2182 Castlereagh Road, Penrith

Section 4.55 Planning Statement

Minor amendments to approved Alterations and
Additions to Existing Bunnings Warehouse

October 2021

Figure 3:

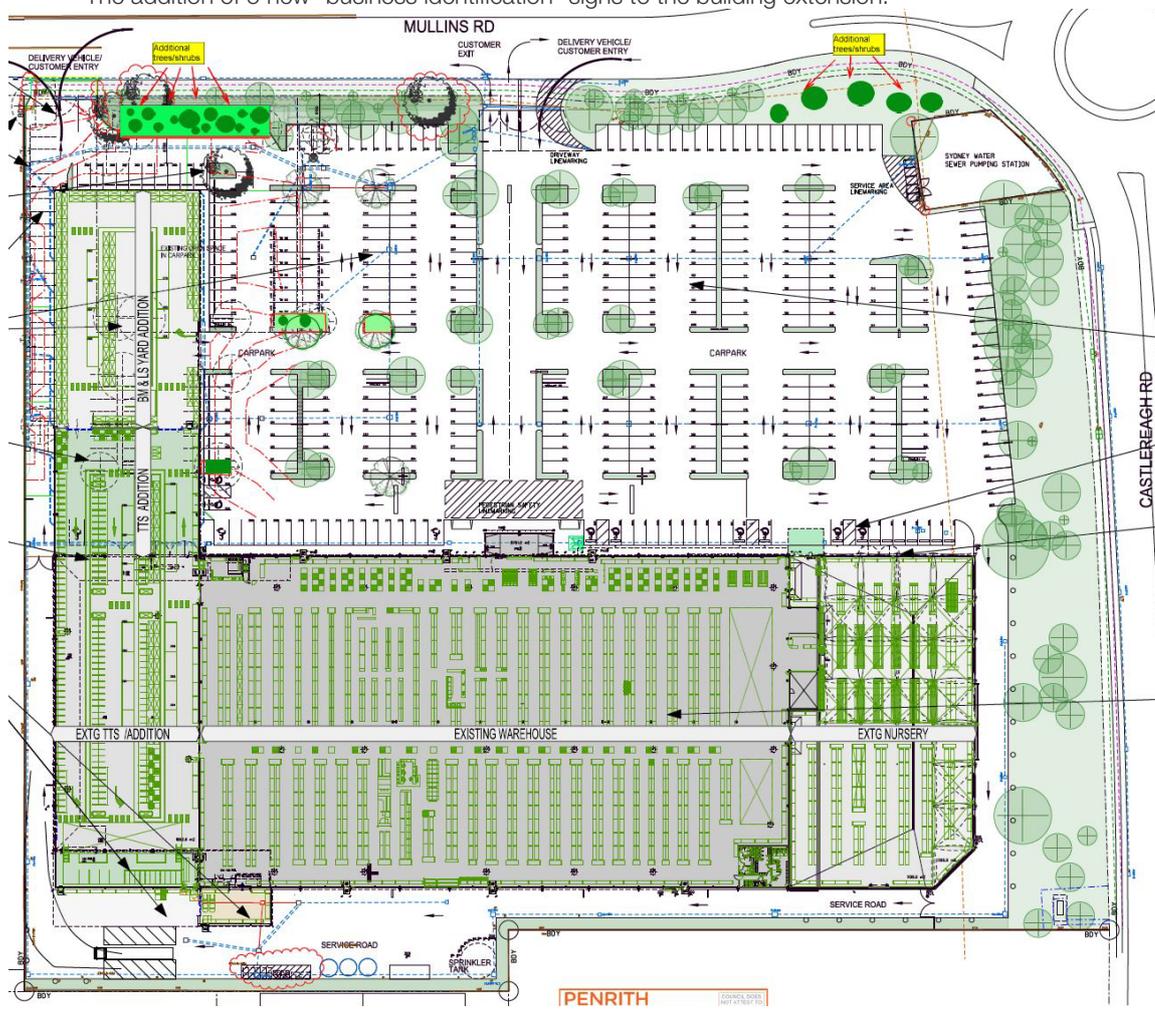
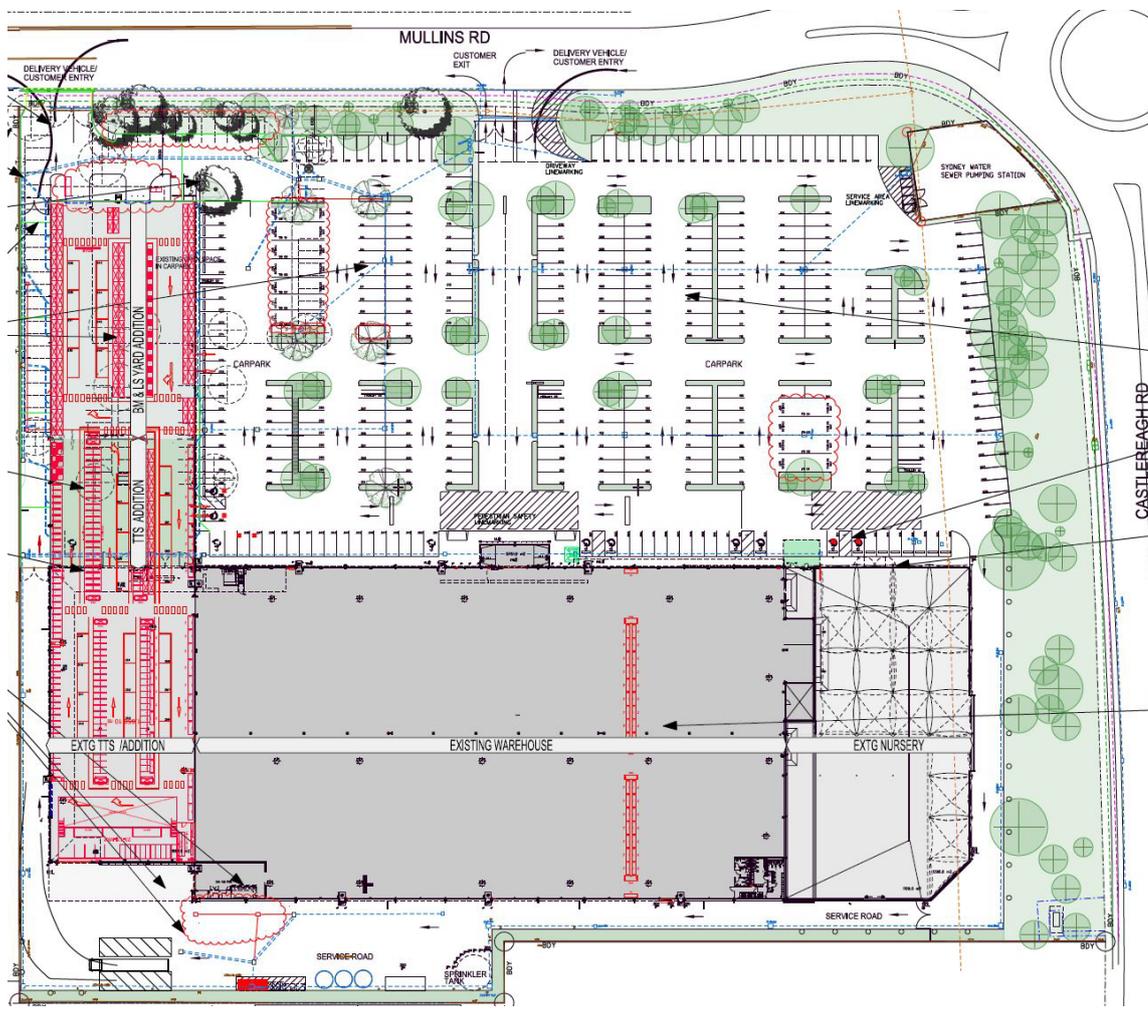
- Enclosure of Building Materials & Landscape Supplies Yard (BMLS Y) with walls instead of fencing.
- Relocation of roller doors to BMLS Y to the north face to improve carpark circulation
- Minor changes to carpark circulation pattern including additional trailer carparking, and associated reduction in car parking spaces
- Removal of the approved extension to the Goods Inwards area at the south west corner of the building.
- Various changes to egress/roller shutter doors.
- Associated changes to landscape arising from changed building and car parking layout and conditions of approval.
- Minor changes to configuration of internal racking
